END OF ADDENDUM NO. 1

TOWN OF BENNETT
NEW WATER STORAGE TANK
DESIGN CRITERIA, PROCESS FLOW DIAGRAM & HYDRAULIC PROFILE

WATER STORAGE UPGRADES SHT 03 OF 44

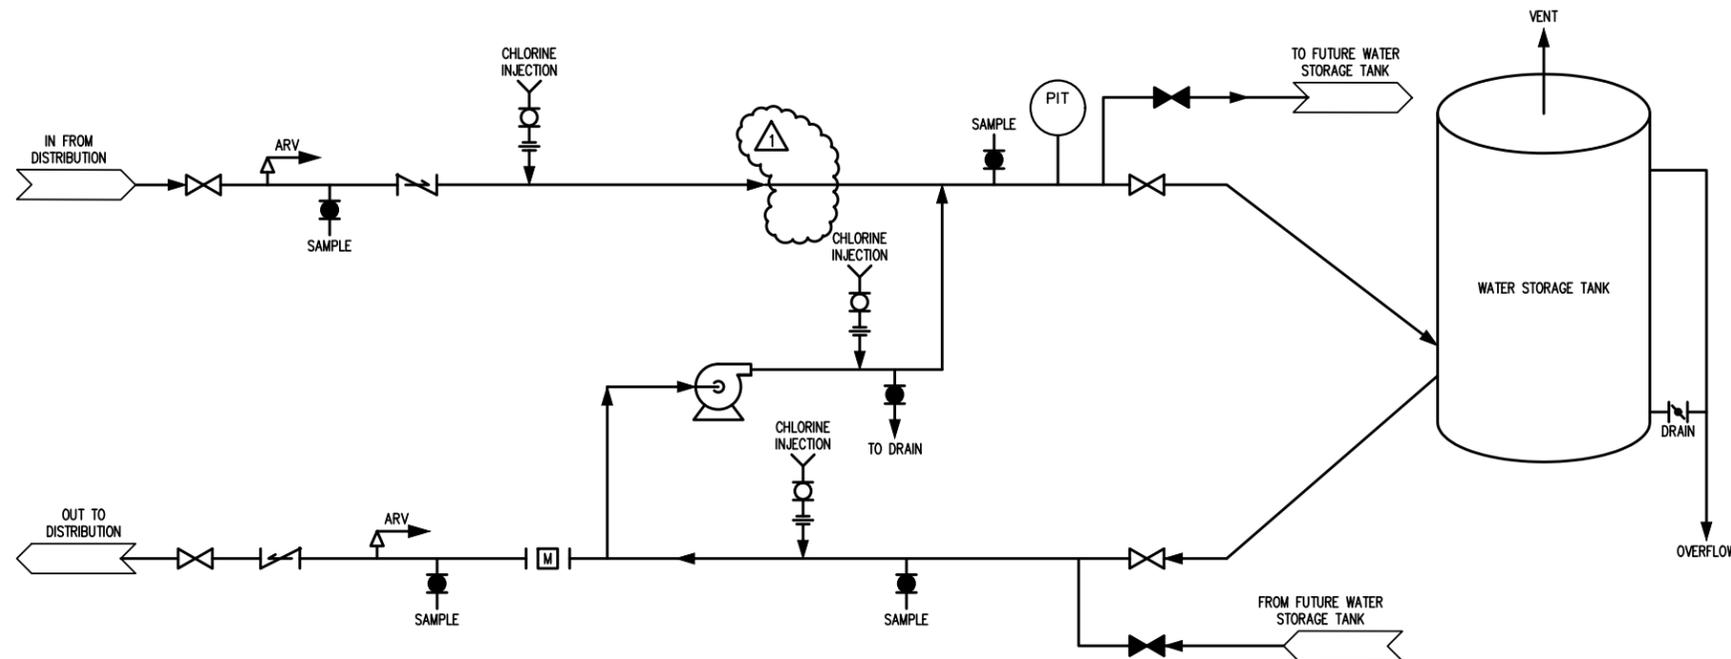
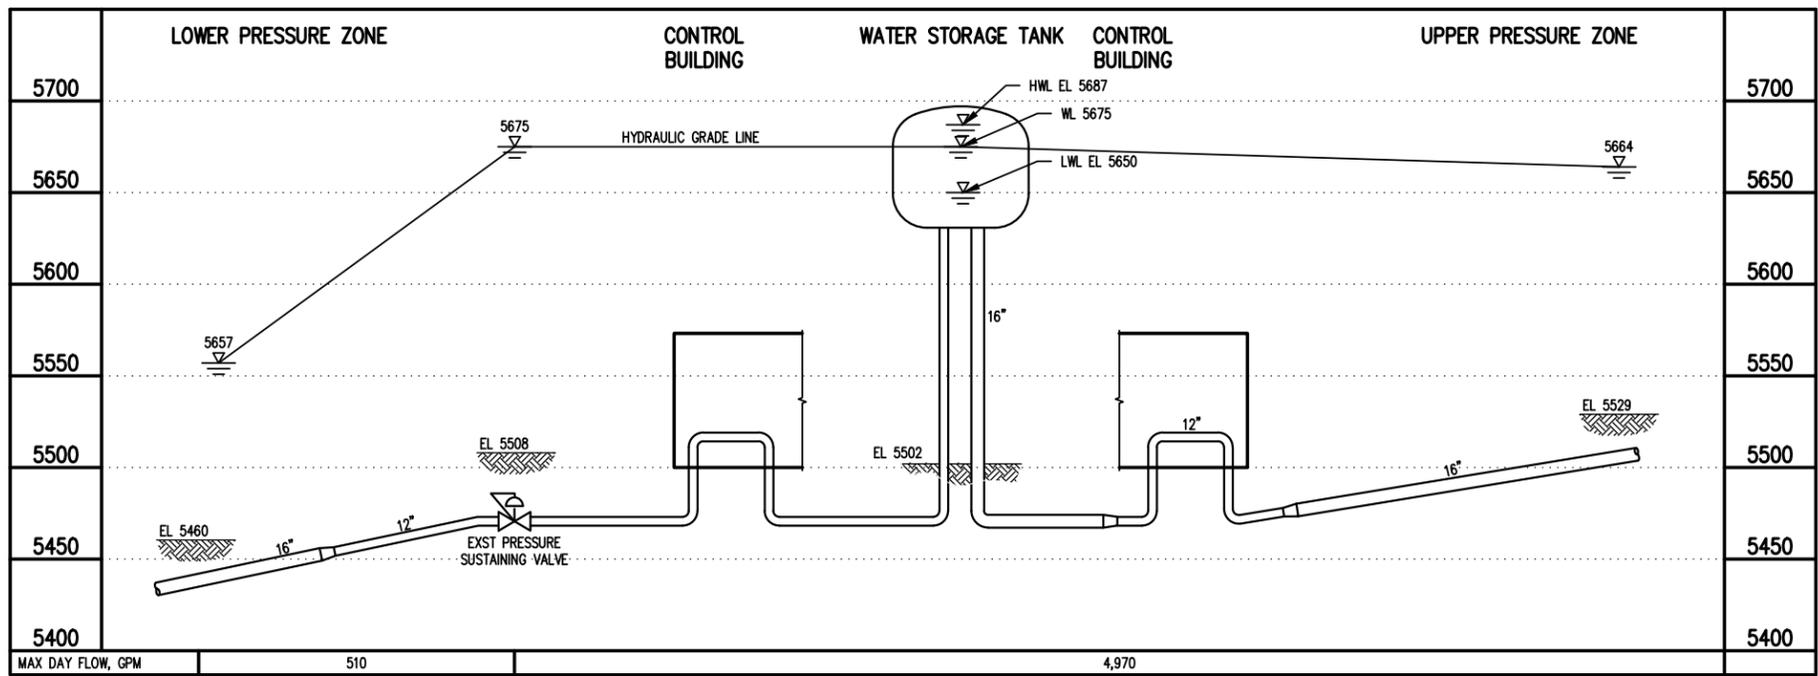
- A. Sheet No. 03 of 44: Design Criteria, Process Flow Diagram & Hydraulic Profile
 - 1. The Town will use tank level and SCADA to control tank fill cycles, so the altitude valve is not needed. Altitude valve removed.

TOWN OF BENNETT
 NEW WATER STORAGE TANK
 WATER STORAGE TANK P&ID

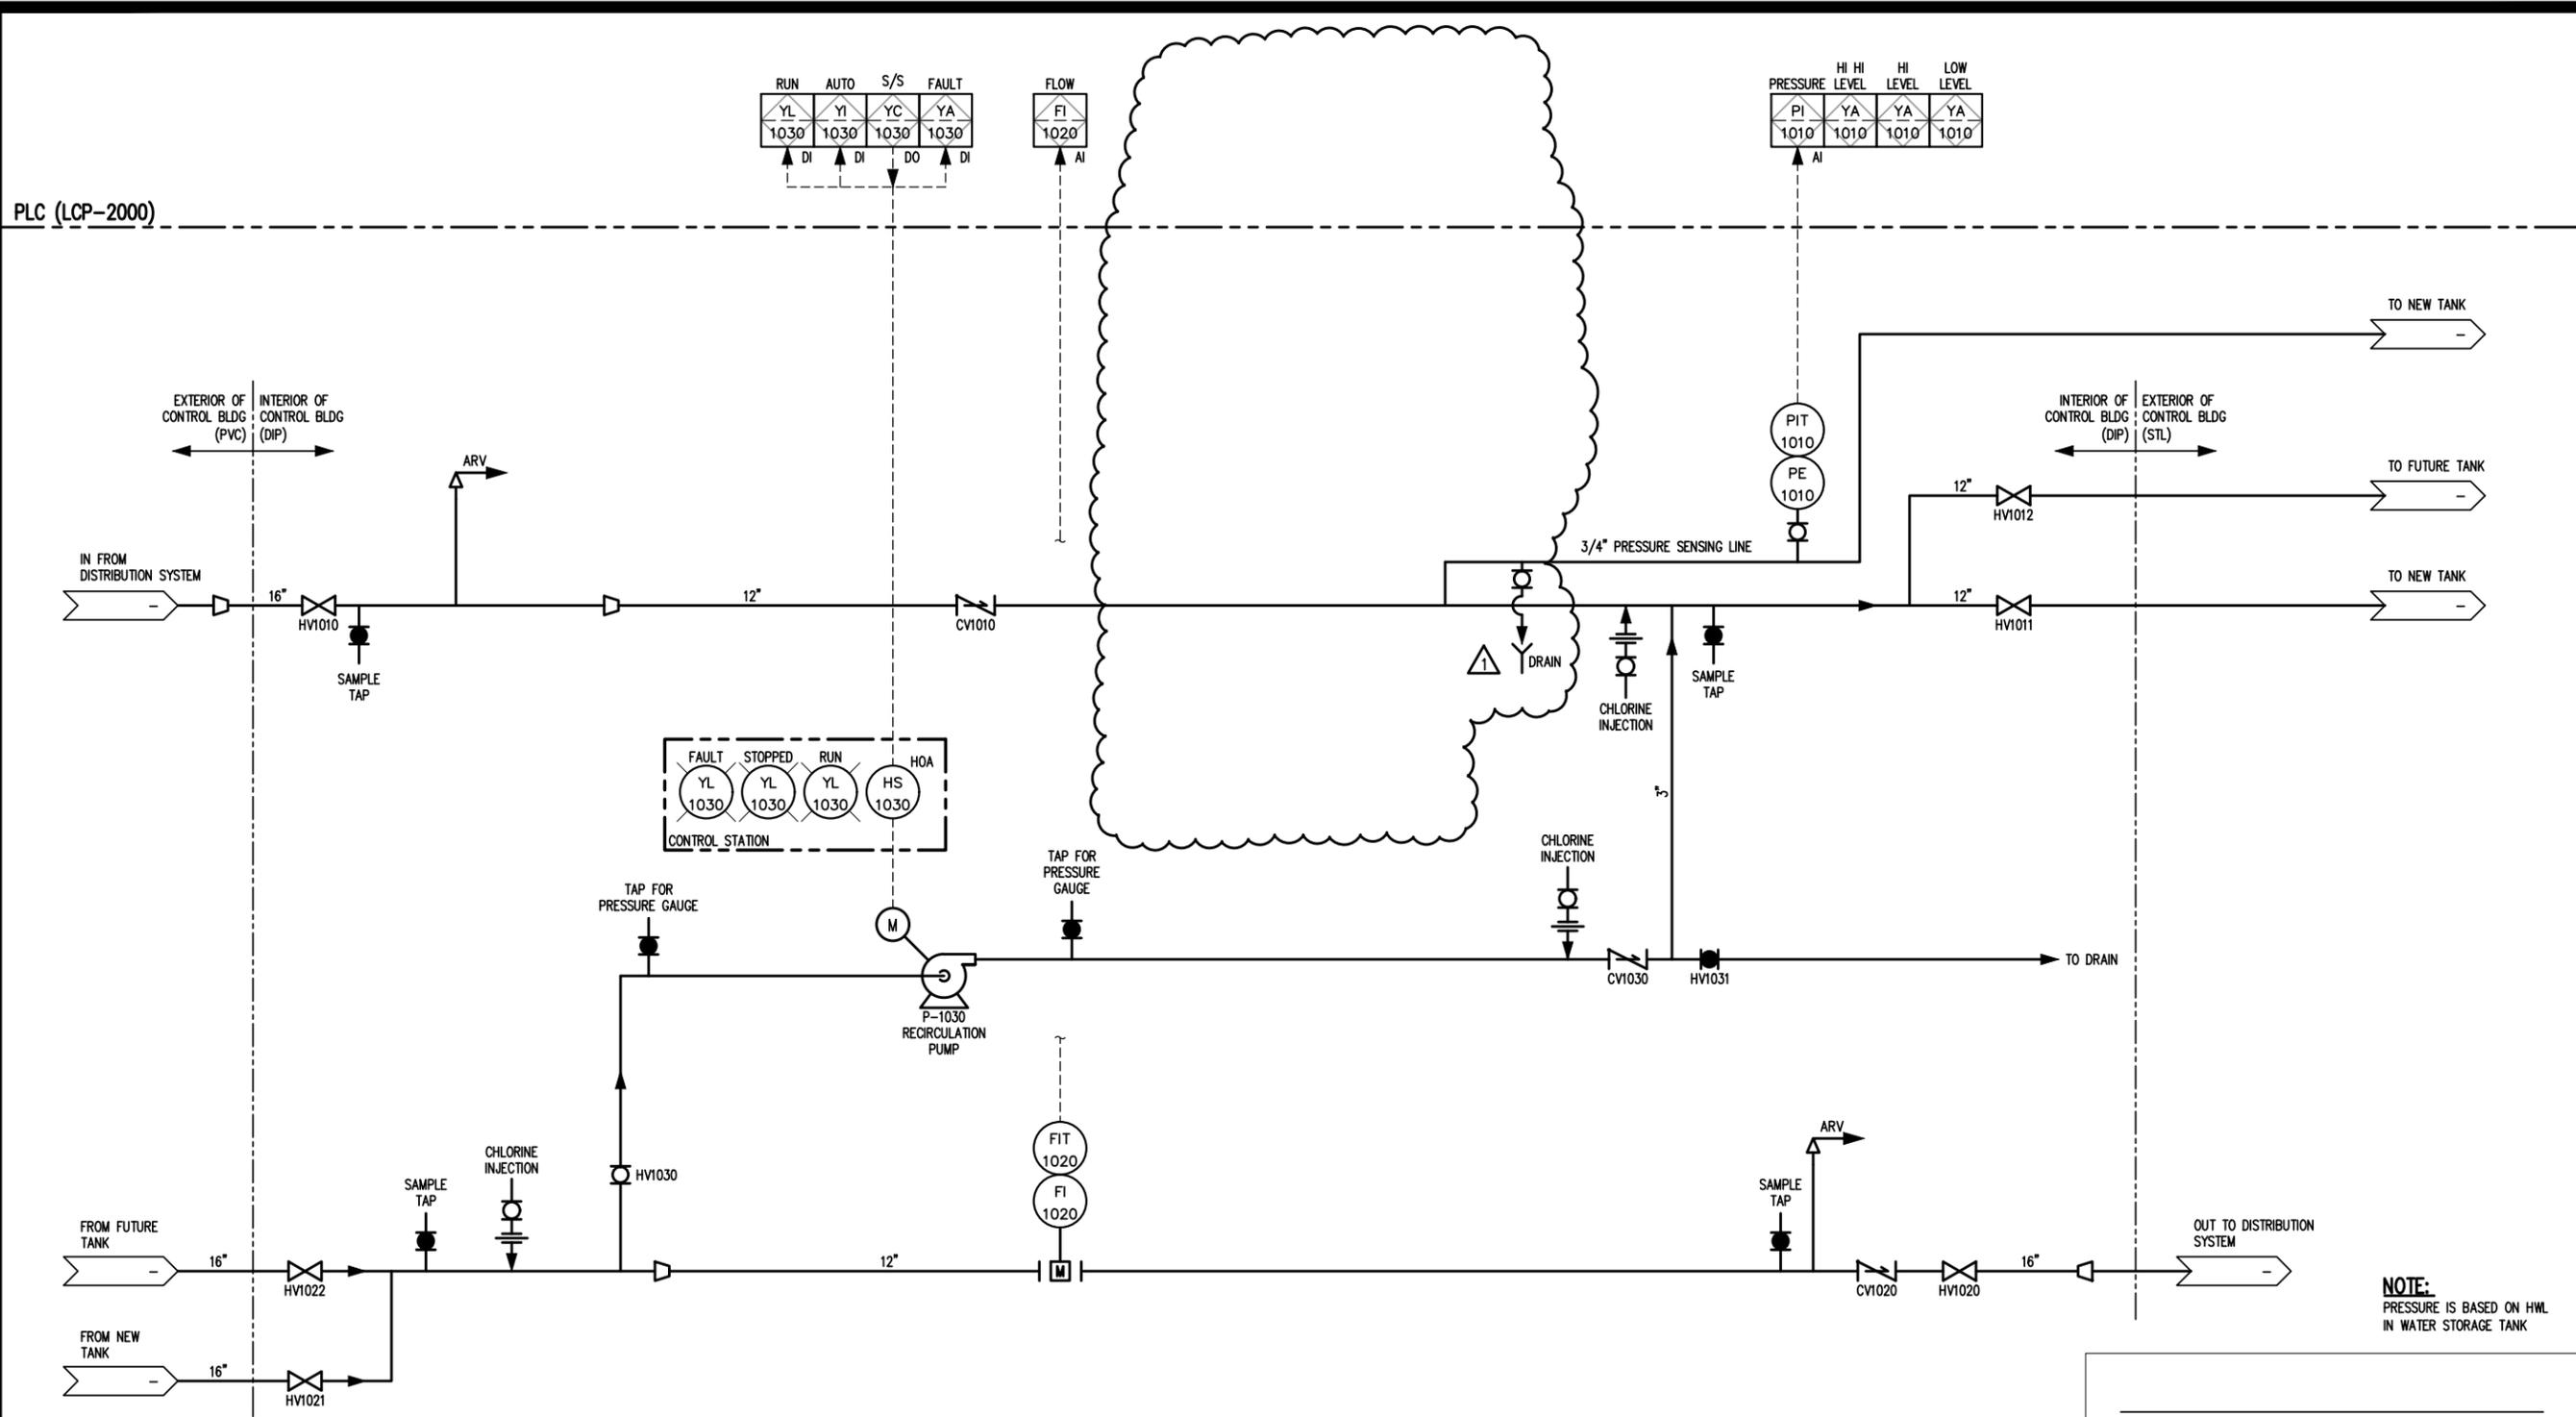
- B. Sheet No. 05 of 44: Water Storage Tank P&ID
 - 1. Altitude valve removed.
- C. Sheet No. 33 of 44: Control Building Plan
 - 1. Altitude valve, upstream and downstream 12-inch gate valves, altitude valve bypass line and 12-inch gate valve removed. Pressure sensing line relocated. Pressure sensing line for future tank removed.

TOWN OF BENNETT
NEW WATER STORAGE TANK
CONTROL BUILDING
SECTIONS

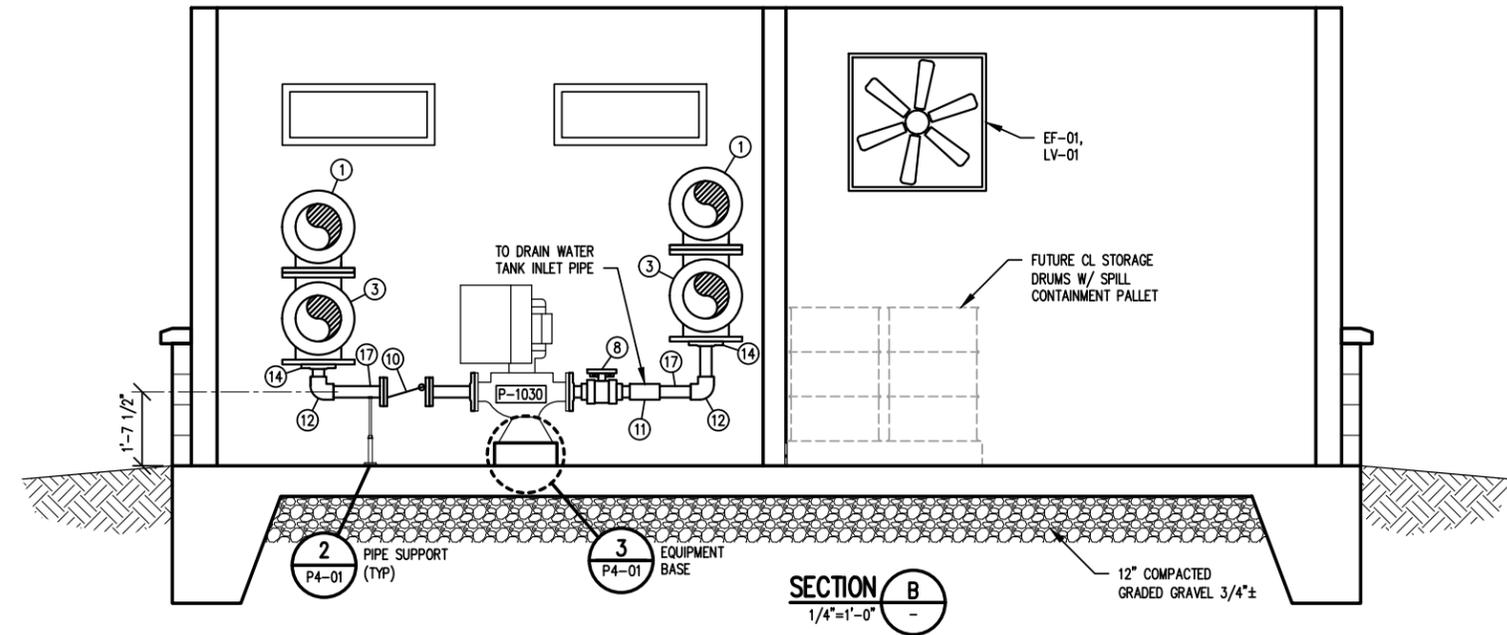
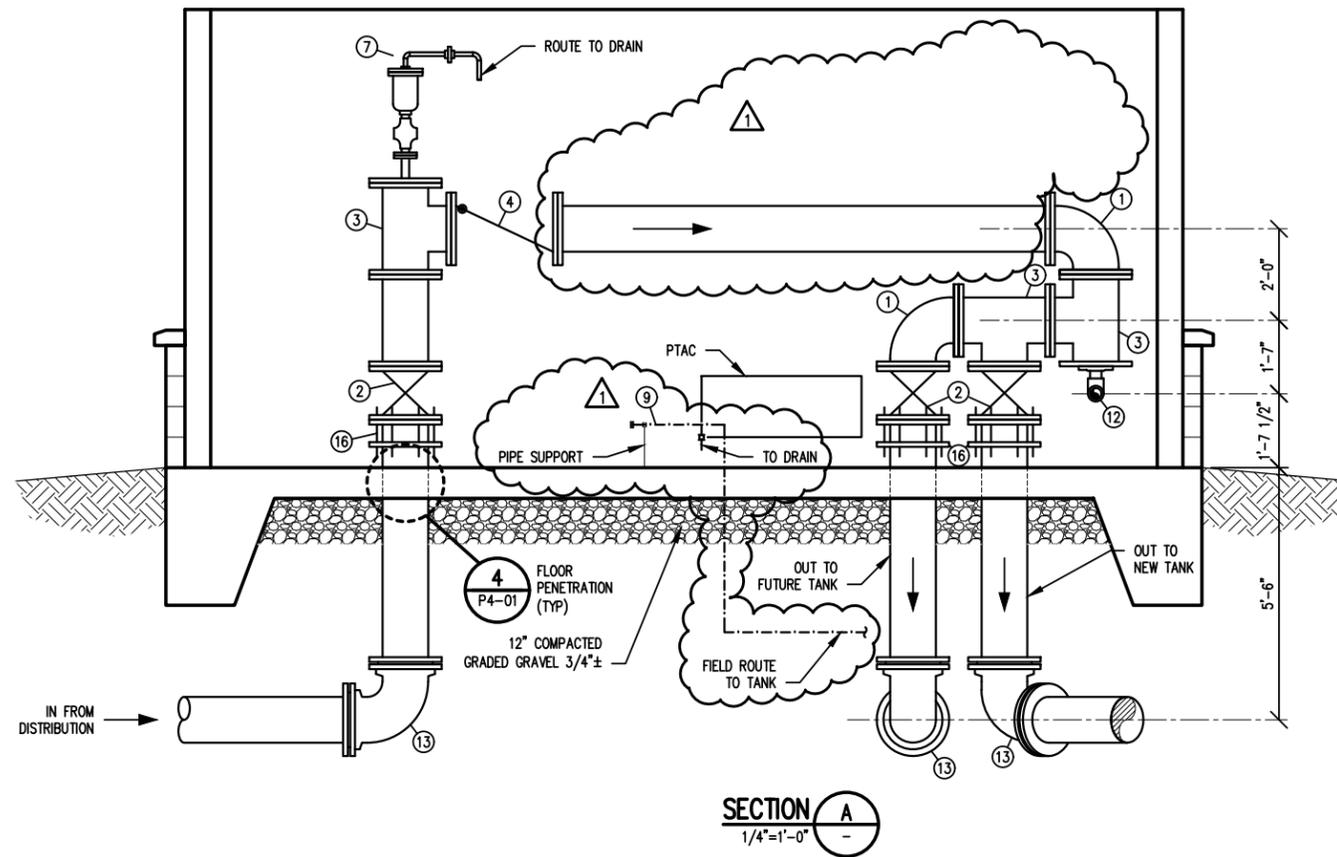
- D. Sheet No. 35 of 44: Control Building Sections
 - 1. Altitude valve, upstream and downstream 12-inch gate valves, altitude valve bypass line and 12-inch gate valve removed. Pressure sensing line relocated. Pressure sensing line for future tank removed.

**RECIRCULATION PUMP SCHEMATIC
& PLC ONE-LINE**

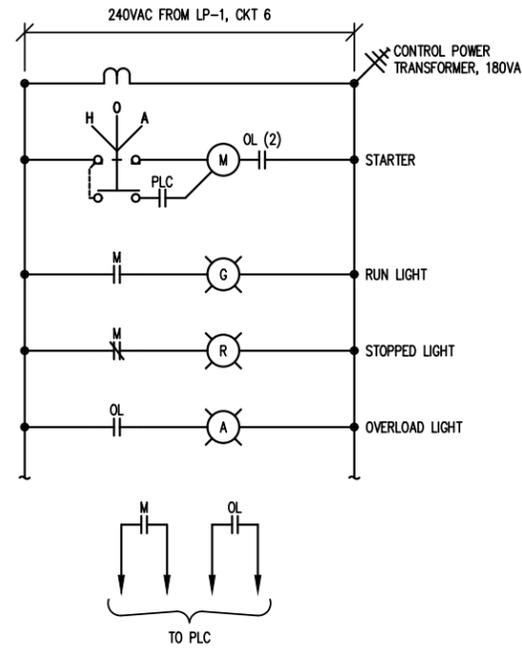
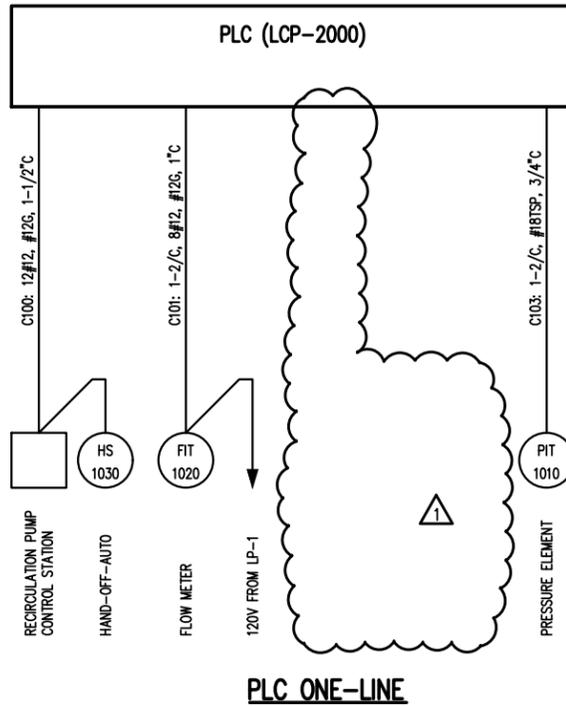
- E. Sheet No. 40 of 44: Recirculation Pump Schematic & PLC One-Line
 - 1. Altitude valve removed.
